DOCKETED	
Docket Number:	23-AFC-03
Project Title:	Black Rock Geothermal Project (BRGP)
TN #:	255266
Document Title:	Black Rock PDOC Comments and Exhibit A
Description:	N/A
Filer:	Alisha Pember
Organization:	California Unions for Reliable Energy
Submitter Role:	Intervenor
Submission Date:	3/25/2024 4:51:19 PM
Docketed Date:	3/25/2024

Re: **California Unions for Reliable Energy's Comments on Preliminary Determination of Compliance for the Black Rock Geothermal Power Generation Plant**

Subject: Comment Letter Black Rock Geothermal Project Preliminary
Determination of Compliance (PDOC)

Figure 6: Spatial Overview of the Applicant's Three Geothermal Projects - Elmore North Geothermal Project (ENGP), Black Rock Geothermal Project (BRGP), and Morton Bay Geothermal Project (MBGP)

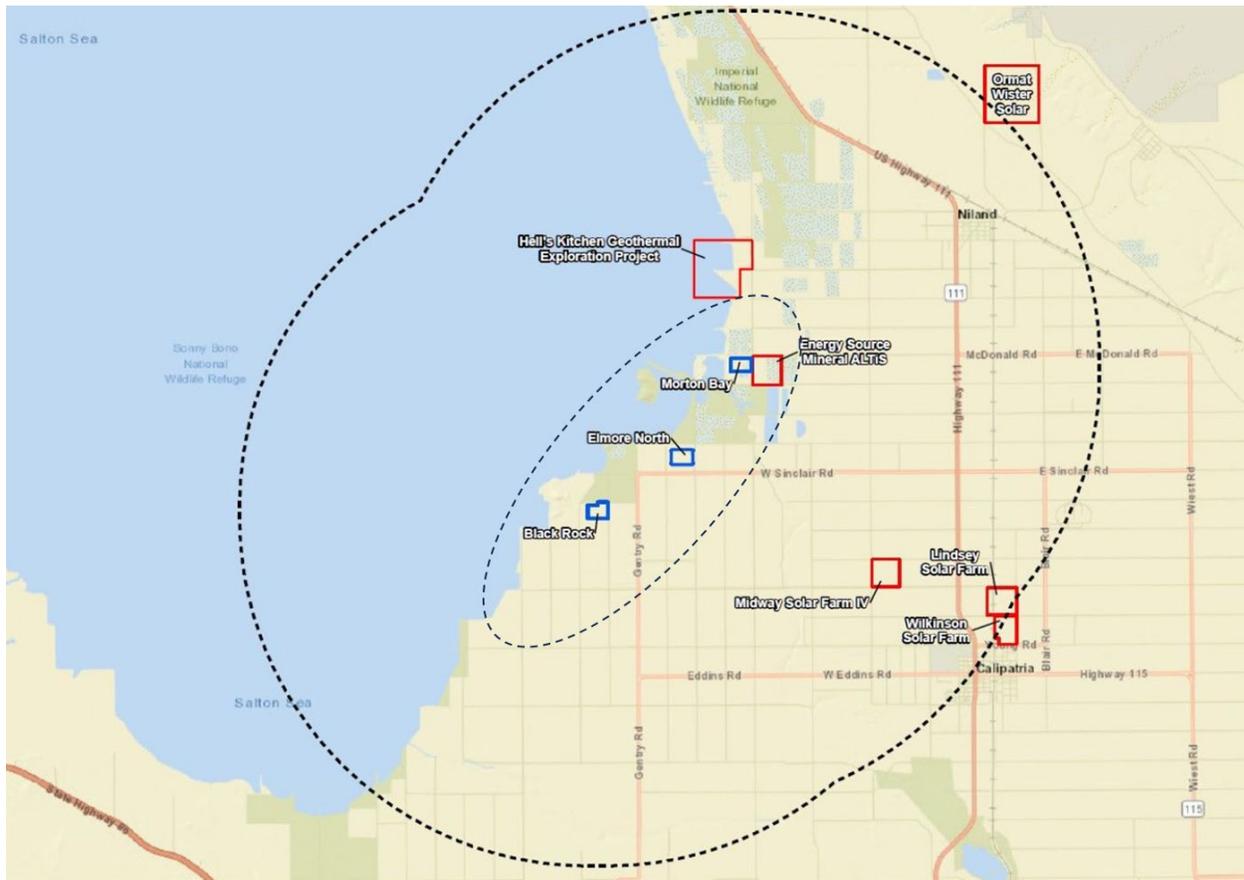
The PDOC fails to account for the cumulative impact arising from both existing geothermal projects and other proposed ventures by the Applicant in the immediate vicinity of the BRGP. Notably, the operational geothermal projects and the Applicant's additional proposed developments, namely the Elmore North Geothermal Project and the Morton Bay Geothermal Project, are situated near the BRGP (Figure 6). The absence of an integrated evaluation considering these coexisting projects raises significant concerns about the overall completeness and accuracy of the environmental impact assessment. Emissions from the three projects were quantified separately and have not been combined to determine the cumulative impacts on the surrounding community. The potential cumulative effects on air quality, emissions, and overall environmental health necessitate a comprehensive analysis that encompasses the combined influence of all geothermal activities in the region. Addressing this oversight is paramount to ensure a thorough understanding of the cumulative environmental impact of geothermal projects in the area.

Notably, the cumulative analysis lacks a calculation of the annual maximum CAAQS PM_{2.5} and PM₁₀ concentrations from all three facilities. The presented data highlights the individual annual maximum CAAQS PM_{2.5} and PM₁₀ concentrations from the Black Rock, Morton Bay, and Elmore North geothermal plants. However, a comprehensive evaluation of the cumulative impact of emissions from all three plants is notably absent.

Figure 8: Map Illustrating Project Location (BRGP) with Sonny Bono, Niland, and Brawley Monitoring Stations in Proximity

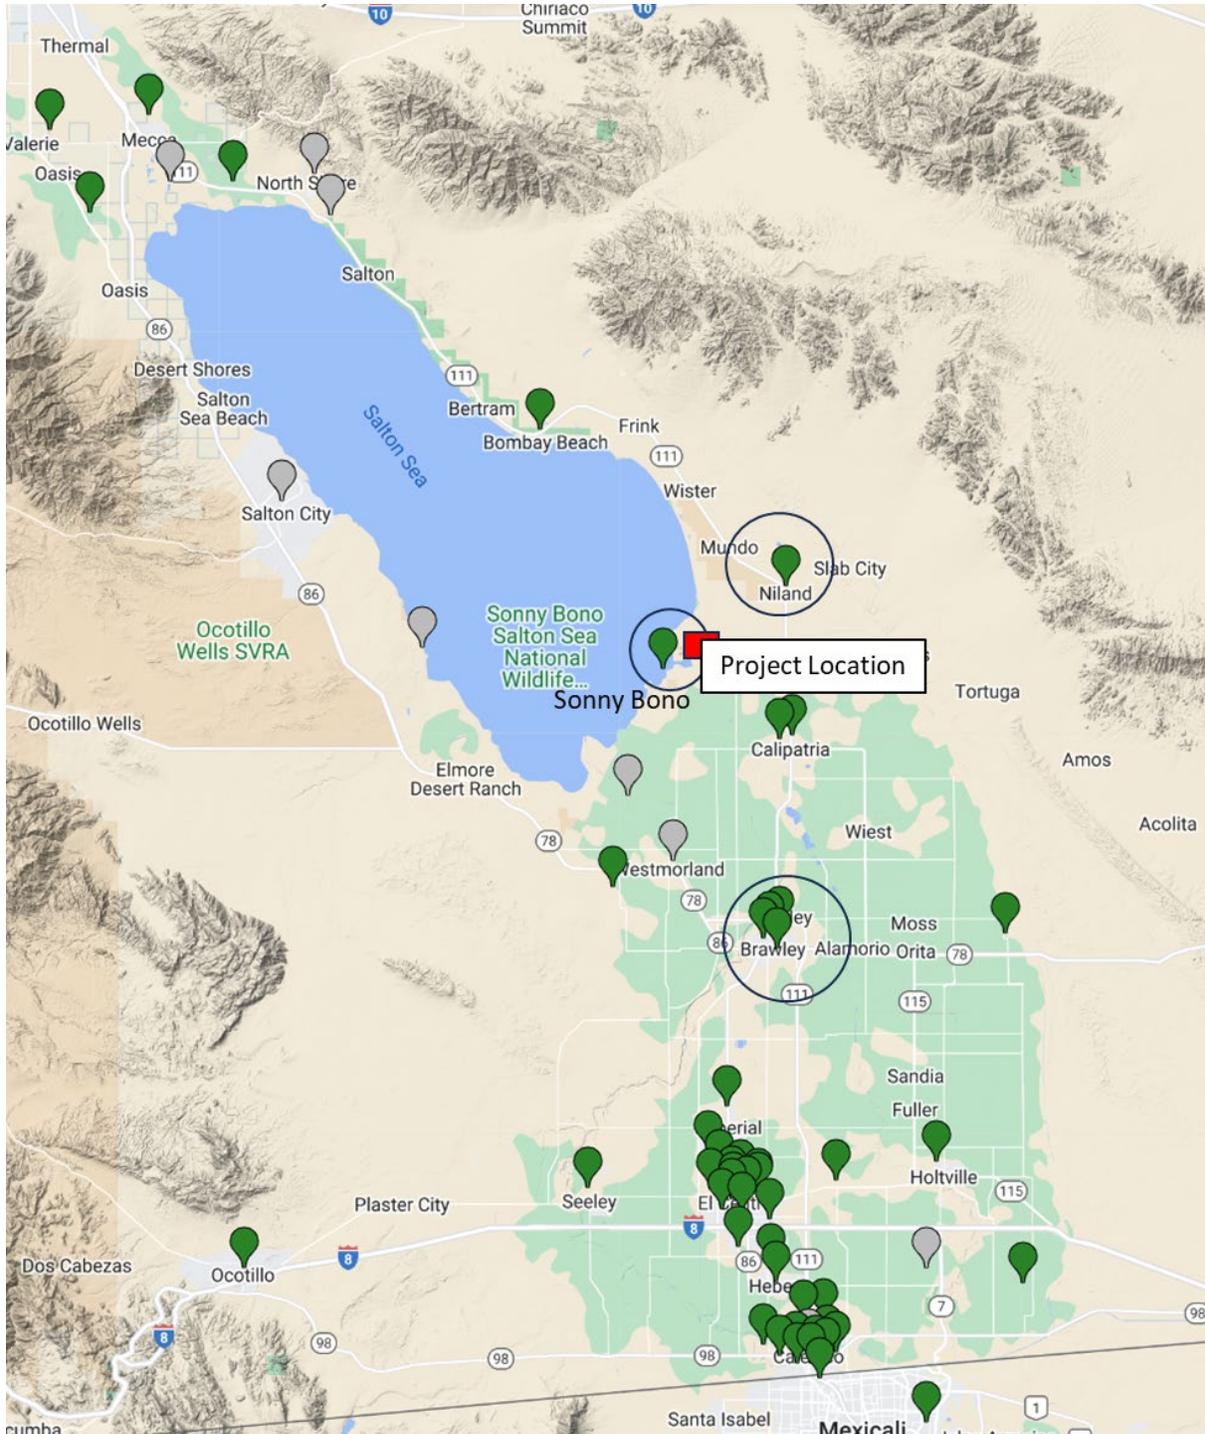
Furthermore, the selection of monitoring stations for PM₁₀ and PM_{2.5} concentrations, such as Niland-English Road and Brawley-220 Main Street, respectively, raises serious concerns about the representativeness of the chosen locations (Figure 7 and Figure 8)¹⁵. A more comprehensive and critical approach utilize background concentration values from the Sonny Bono station, which not only is in closer proximity but also covers the more recent years of 2021 and 2022, thereby providing a more accurate depiction of current background pollution levels.

Figure 9: 2023 Air Quality Concentrations of $\text{PM}_{2.5}$ and PM_{10} at Sonny Bono Monitoring Station

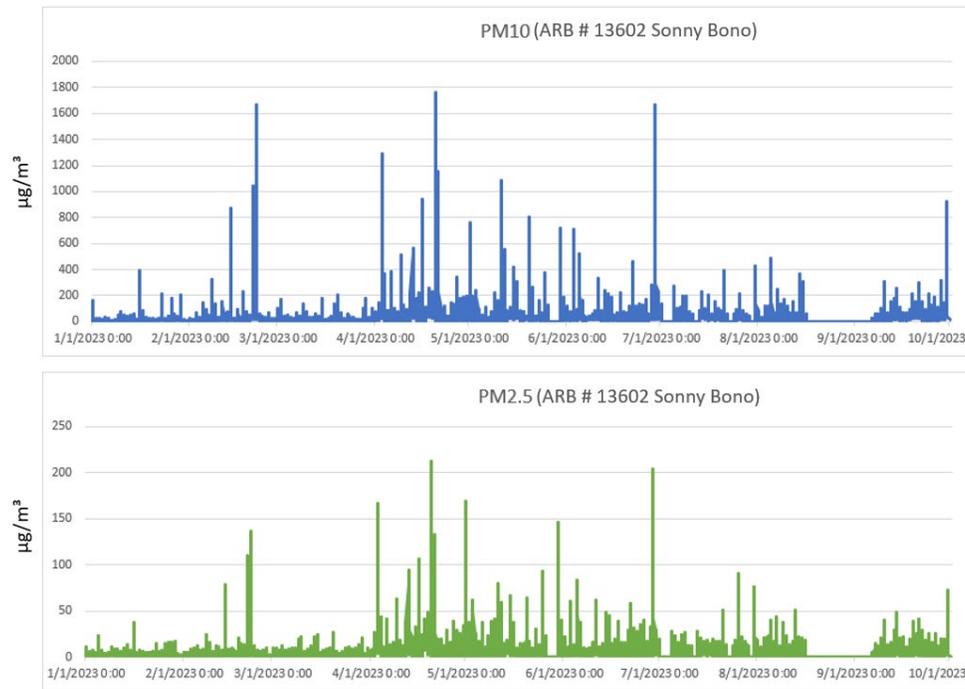
In essence, the discrepancies in the choice of background concentrations and monitoring stations, particularly the omission of the more pertinent Sonny Bono data (see 2023 particulate matter concentrations in the figure below, Figure 9), introduce uncertainties into the accuracy and reliability of the air quality permit application and PDOC because the PDOC's conclusions rely on ambient conditions that are not representative of conditions in the immediate vicinity of the project site. The emissions analysis must be revised to incorporate an analysis of local background conditions in order to accurately assess the Project's net increase in emissions and assess compliance with AAQs. .

Figure 11: Wind Rose Plot Illustrating Wind Conditions at Imperial County Airport Monitoring Station

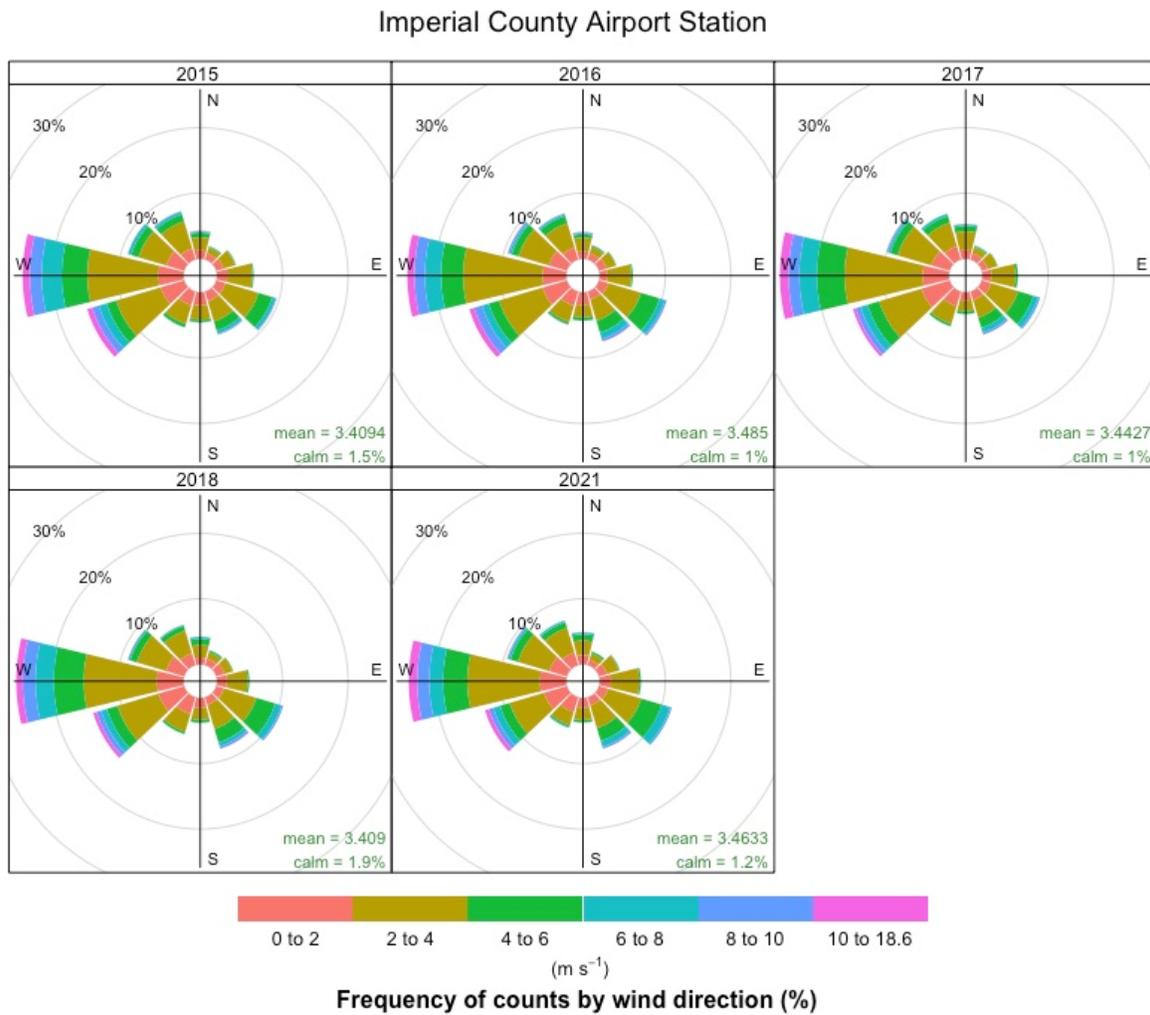
The examination of wind speed, elucidated through wind rose plots for both KIPL and Sonny Bono stations (Figure 11 and Figure 12), is pivotal for understanding the atmospheric dispersion patterns. Notably, KIPL registers an average wind speed of 3.4 m/s, marginally lower than Sonny Bono's 3.51 m/s. However, the key differentiator lies in the prominent wind directions at these locations, with Imperial exhibiting notably calmer conditions.
